Project Address: 1411 S. Potomac St. Unit # 400 Zip code: \_\_\_\_\_  
Project Name: Colorado Orthopedic Consultants  
Contractor Company Name: TBD Phone: \_\_\_\_\_ Fax: \_\_\_\_\_  
Contact Person: \_\_\_\_\_ Phone: \_\_\_\_\_  
Email: \_\_\_\_\_ Fax: \_\_\_\_\_

Tenant Improvement Build-out Colorado  
Orthopedic Consultant

RSN: 619637  
Permit #: 2011558118

DRAWN BY: CHECKED BY:

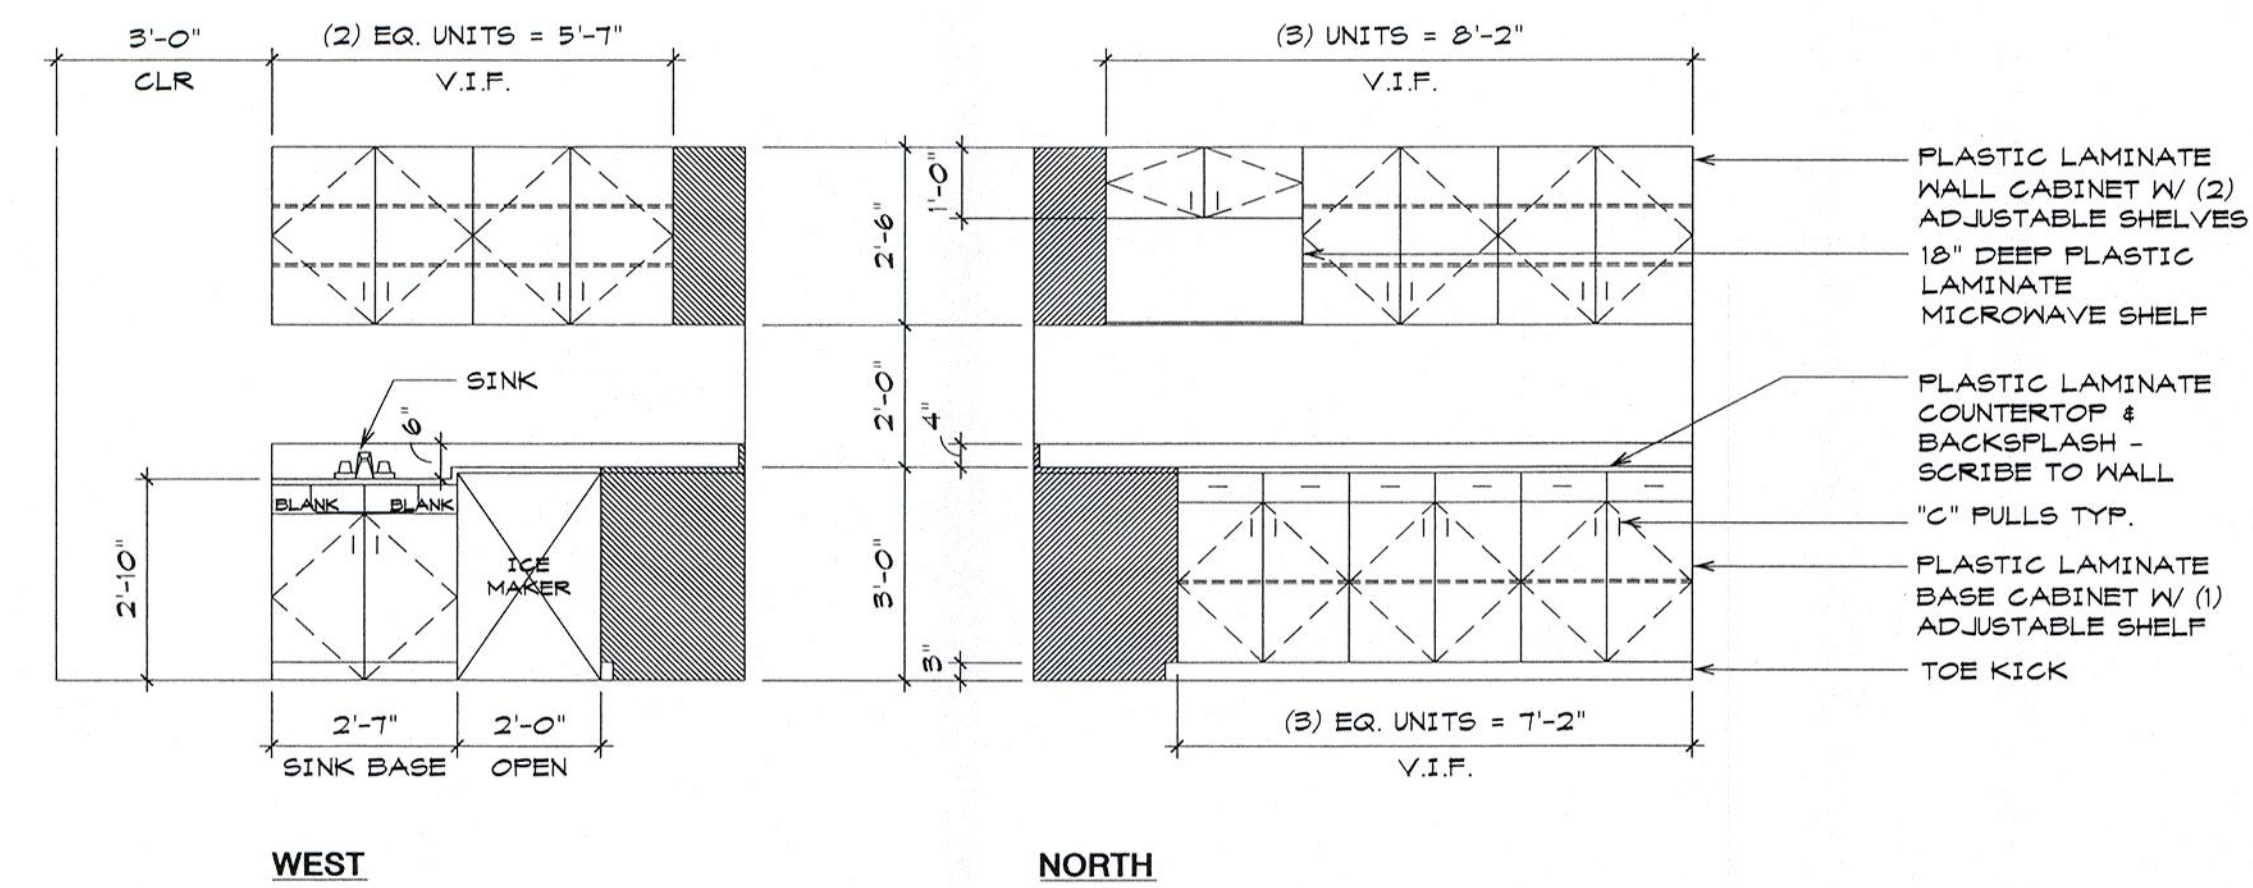
After hours inspection to verify required gross illumination may be required during field inspection. 2009 IBC 1006
